工程指示 / 要求簡箋(E.I.)

工程指示編號：EI / 4257 / 22

工程名稱：天水圍天榮站

工程項目：Trial panel Schuco 門(修改 S.O 數)

PLAN OF PRECAST FACADE UNIT (T3-A5)
1:30

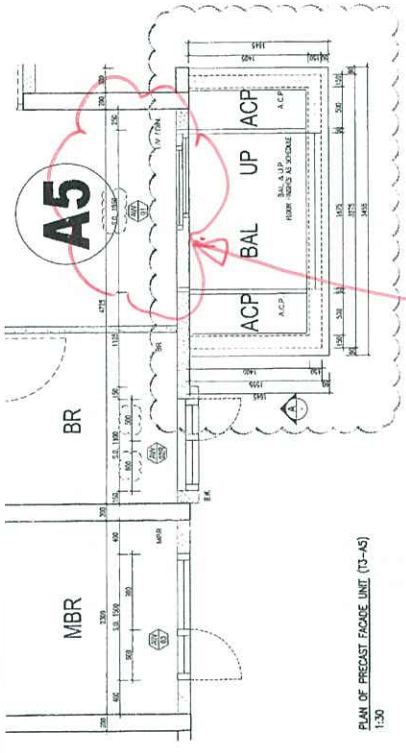
1. The structural opening for sliding door changed from 1800mm(W) to 1950mm(W).
2. The dimension of balcony (A5) changed from 3364(L) x1515(W)mm to 3275(L)x1555(W)mm.

ELEVATION A (T3-A5)
1:30

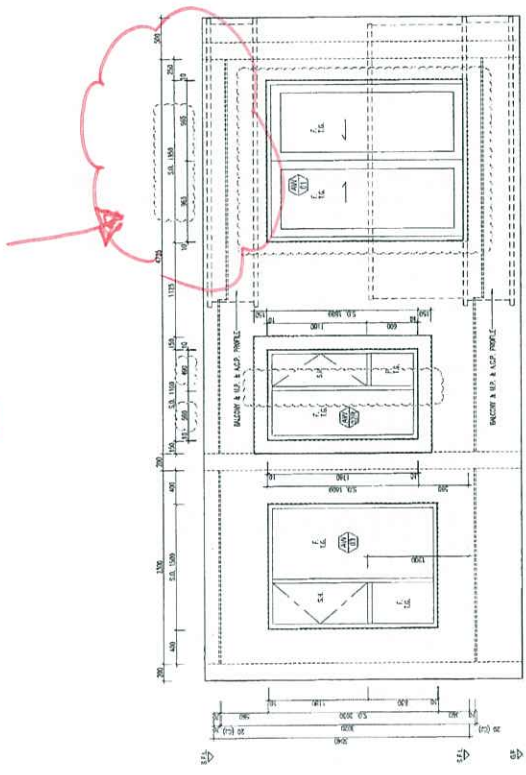
5.0 1800mm 改為 1950mm

C 版：因圖紙有所更正，旭格趟門尺寸由(2348(H)x1800(W))更改為((2348(H)x1900(W))，請以這尺寸為準。
